## INVITATION TO BID

Envelope Renovations  
at  
Sandpiper Apartments 1312 139th Ave NE, Bellevue, WA 98005

### ADDENDUM NO. 1

**CONTRACT NUMBER:** AW2501631

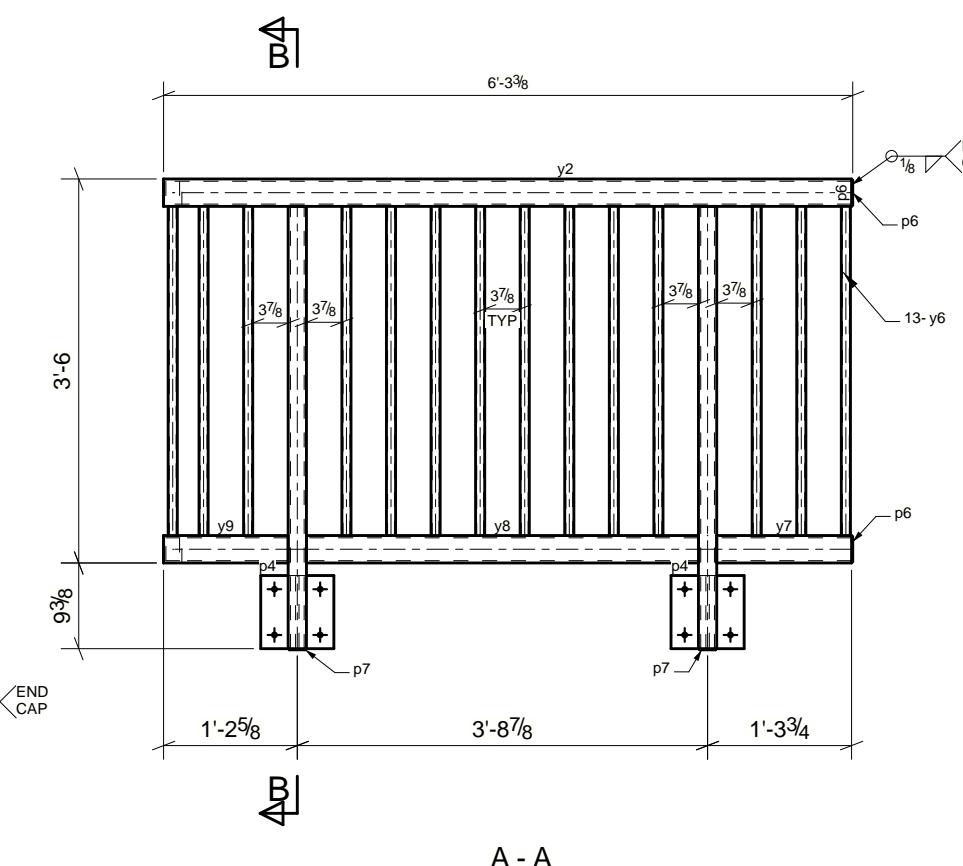
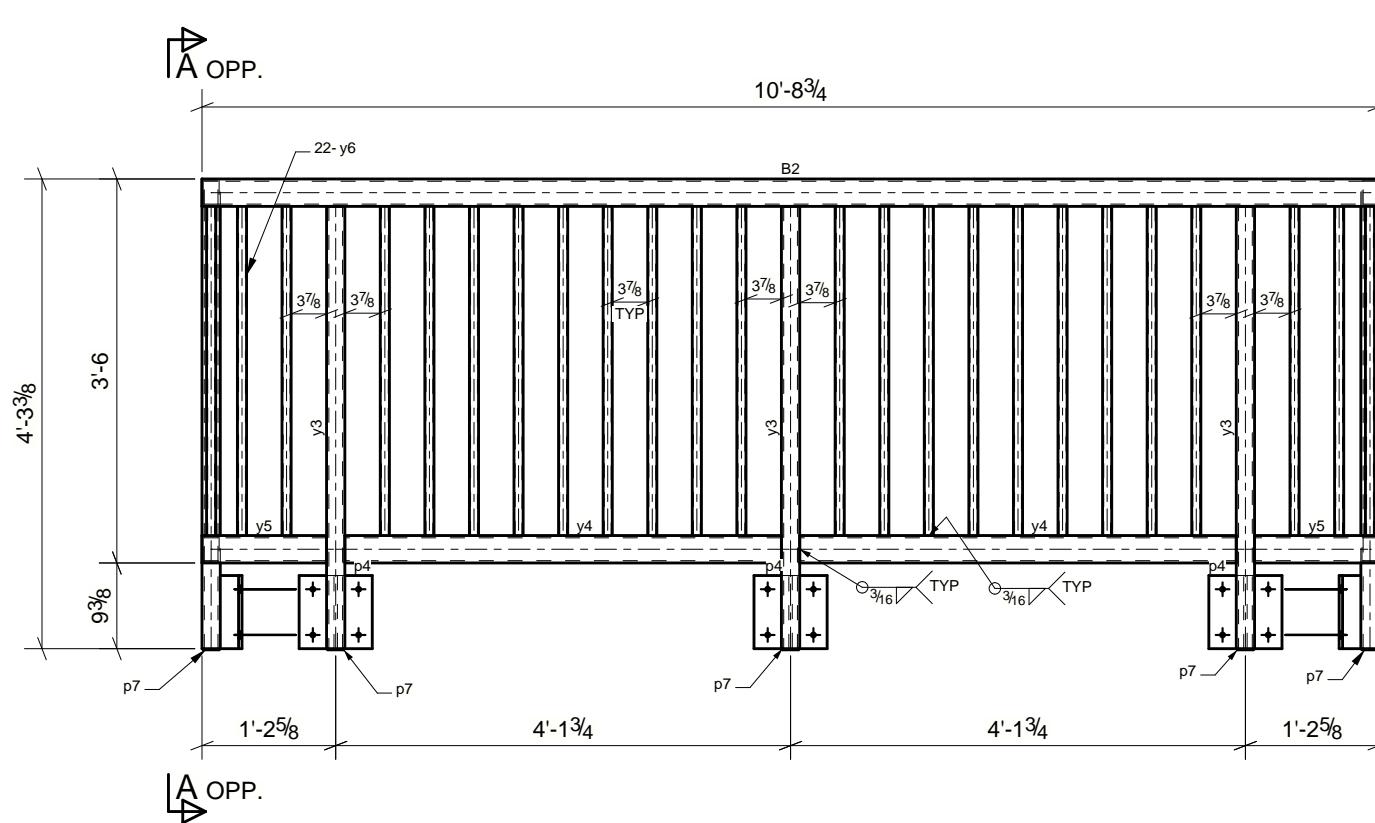
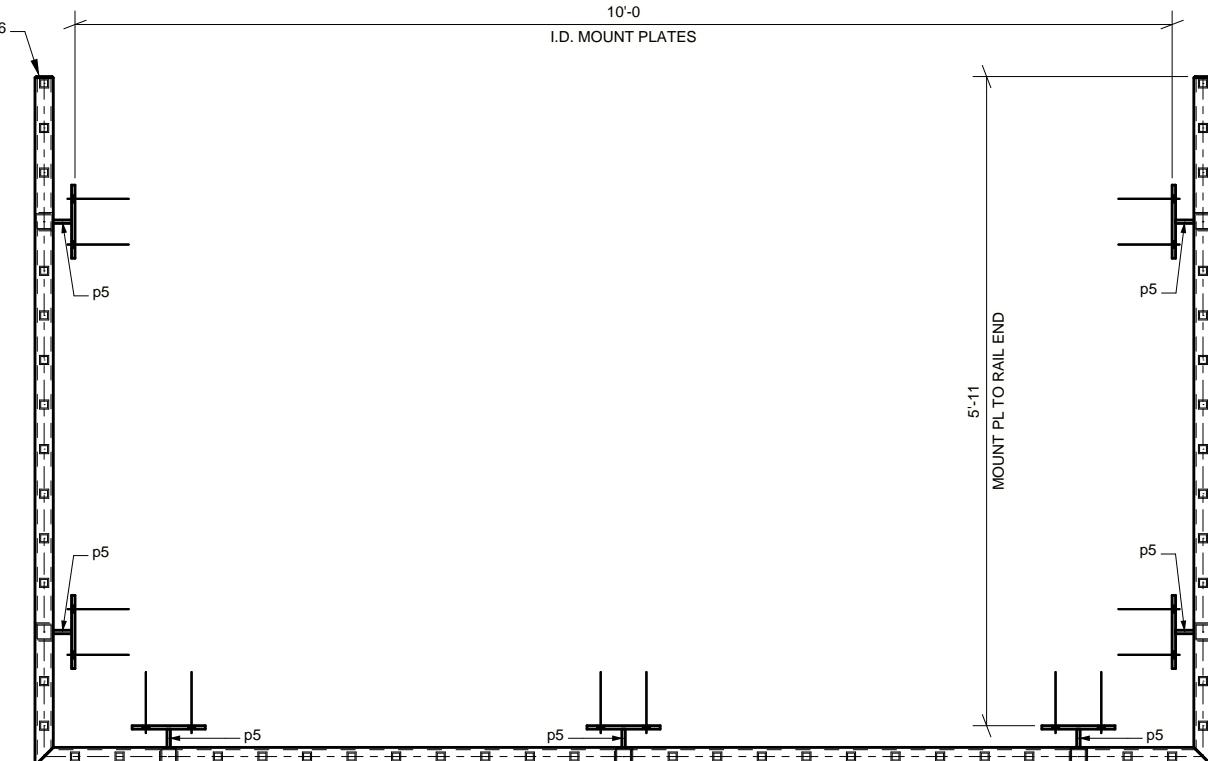
**Q2.** Plans show new handrails. All details on S2.1 show the handrail but says guardrail assembly by others. Is the railing part of the base bid? Confirm railing spec, design, and color.

**A2.** Yes, the railing is part of the base bid. Please see attached Sample Railing Diagram (R.1 & R.2) for example of railing design for bidding purposes. Keynote 6 in Bid Set dated 10/22/25 “Remove existing wood-framed guardrails and install new metal face-mounted picket guardrails.” Color TBD, (Black, White or Burgandy) to match Leasing office colors. Contractor to provide specs for proposed railing design.
